# What We Heard Report

## Park Design Workshop

Parkline | 2501 Richmond Road

April 6, 2026

**PARKLINE**  
**Proposed Park Plan**

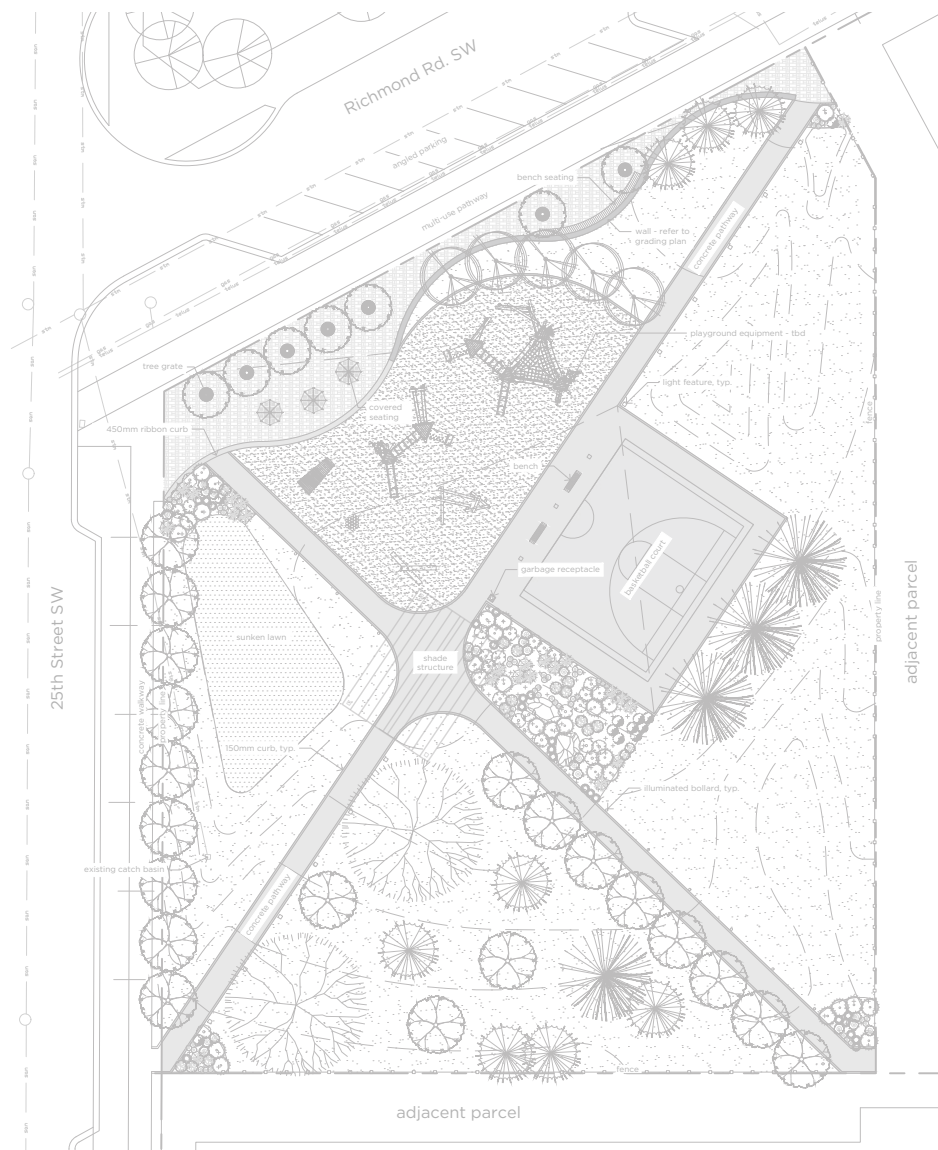
THEME AREA	LIKES	DISLIKES / OTHER CONSIDERATIONS
<b>Trees</b>	<ul style="list-style-type: none"> <li>trees</li> </ul>	<ul style="list-style-type: none"> <li>use large caliper trees</li> <li>high canopy trees vs. shrubs</li> </ul>
<b>Seating</b>	<ul style="list-style-type: none"> <li>seating wall</li> </ul>	<ul style="list-style-type: none"> <li>more seating</li> <li>ensure sufficient seating in the park, especially given the additional population resulting from new development</li> </ul>
<b>Size of Park</b>		<ul style="list-style-type: none"> <li>the number of activities shown in the plan may be too much for the size of the park (sometimes less is more)</li> <li>the park is too small for the no. of people in the area</li> <li>open space area is too small</li> </ul>
<b>Play Structures</b>	<ul style="list-style-type: none"> <li>location of the playground - like that it's near higher density buildings and setback from the street</li> </ul>	<ul style="list-style-type: none"> <li>consider a climbing wall/structure in playground</li> <li>rubber surface</li> </ul>

<b>Safety</b>	<ul style="list-style-type: none"> <li>lighting along the pathway helps people feel safe</li> </ul>	<ul style="list-style-type: none"> <li>more traffic will negatively impact the safety of park users, and pedestrians in general</li> <li>too dangerous to throw frisbees</li> <li>ensure clear sightlines in urban forest</li> </ul>
<b>Sports Court</b>	<ul style="list-style-type: none"> <li>like the idea of hard surface area for outdoor events</li> <li>like the connection of the sports court to the playground</li> </ul>	<ul style="list-style-type: none"> <li>too small to be functional</li> <li>include a vertical surface for individual play (like a tennis backboard)</li> <li>circular 3-on-3 court</li> </ul>
<b>Lighting</b>	<ul style="list-style-type: none"> <li>pathway lighting</li> </ul>	<ul style="list-style-type: none"> <li>light bollards with outlets for market or community events/vendors</li> </ul>

<b>Other Features</b>		<ul style="list-style-type: none"> <li>enclosed dog area</li> <li>dog relief area at the edges to avoid dead grass; maybe mulch</li> <li>water fountain for humans and dogs</li> <li>create a better sense of arrival; pay homage to the site's original use</li> <li>picnic tables</li> <li>include (angled) parking on 25 Street?</li> <li>pedestrian signal lights at the intersection to make crossing easier</li> <li>enhanced maintenance, not City standard is preferred</li> </ul>

# PARKLINE Proposed Park Plan

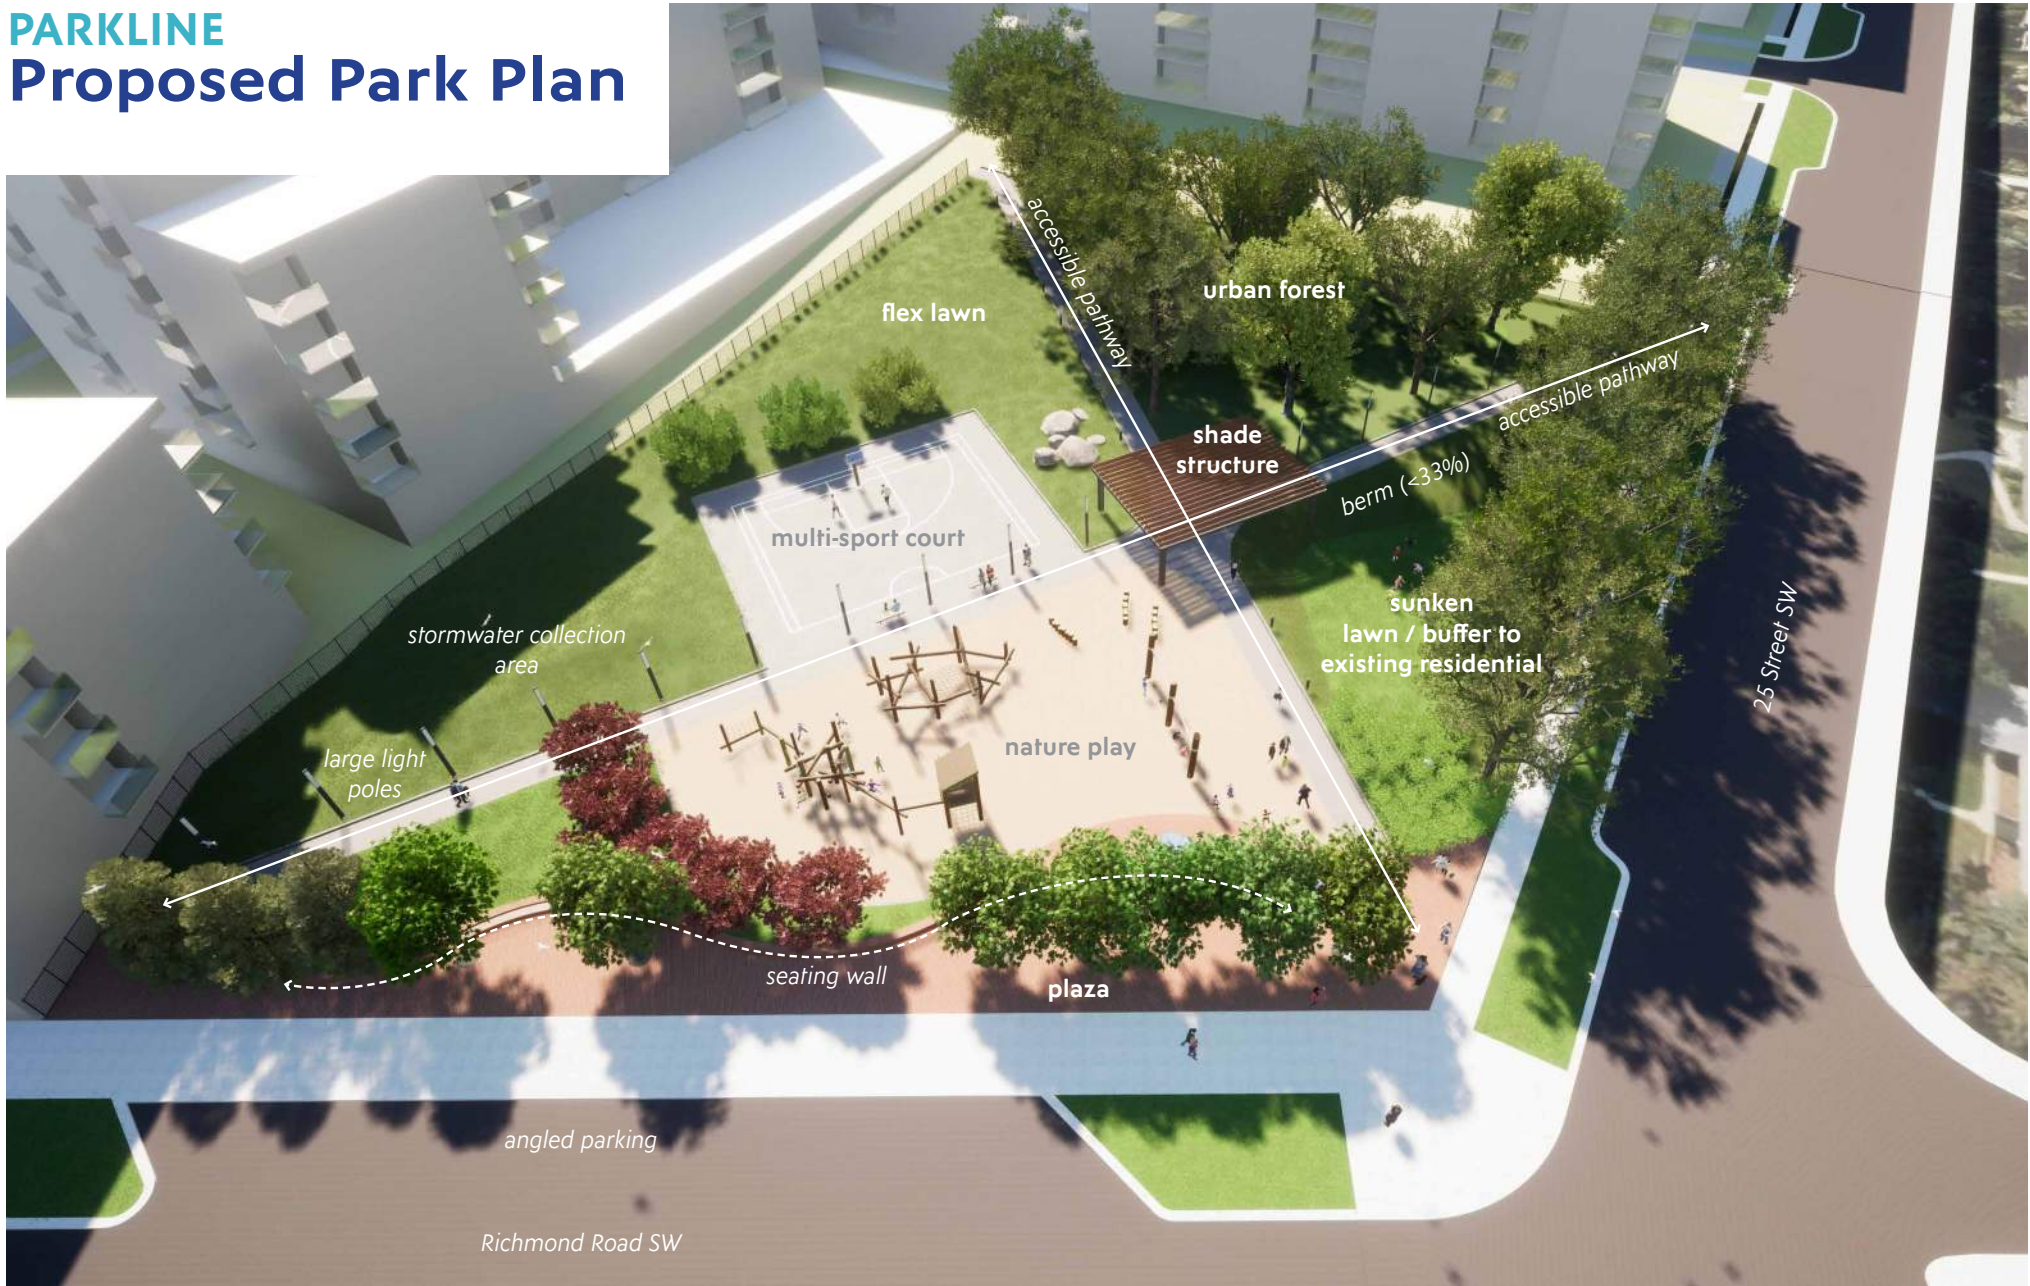
- Like the trees. Climbing wall perhaps, barbeque + picnic tables
- Public art/mural on faces of buildings fronting the park
- Logs/boulders natural play objects for in the tree areas
- Large caliper trees! Don't be stingy
- High canopy trees (instead of bushes)
- Light bollards w/ outlets for market or community events/vendors?
- Rubber play surface with wood playground structures
- Angled parking on Richmond Road; Can some be included on 25 Street?; Seating wall
- Playground and multi-use area near the other higher density buildings (so current area seems good)
- Separation of playground from road
- I like the connection of playground to court; I like the bench seating wall + would like to see it face N and S on the seating wall; I like the overall concepts but wonder if it is too much for the park space.

- 1 acre is too small for this development
- Pedestrian signal lights at the intersection to make crossing easier
- No name?; No "Arrival" pillar or podium?; Sense of history
- Open space too small; Not big enough to throw a frisbee; Need more open space.
- Basketball court too small; Why have ½ a court?
- Rubber surfacing in playground

- Water fountain for humans and dogs (like in Marda Loop) Can some (parking) be included on 25th Street
- There should be a dog relief area at the edges to avoid dead grass; maybe mulch?

- Ideas: picnic tables, visual safety in urban forest area, an enclosed dog area for existing but especially for new people in development; using vertical surfaces around sports court so they can be used for different activities like a ball wall (tennis) or a soccer net.

- Additional seating for retail-adjacent use? "Coffee at the park" (or under shade structure)
- Enhanced maintenance - either prop tax funded or not, but not regular City maintenance

- Homage to Viscount
- Traffic issue; Winter ice etc.
- Multi-use sports court - What else is here other than bball? What is the size? Probably too small for a bball court+ other activities

- How many benches or seating is there in the park? Enough for people in 1,400 units? (3000 people)
- Because of the slope of the site + where the park is located with the buildings on the east + south sides of the park, it will be shadowed constantly.
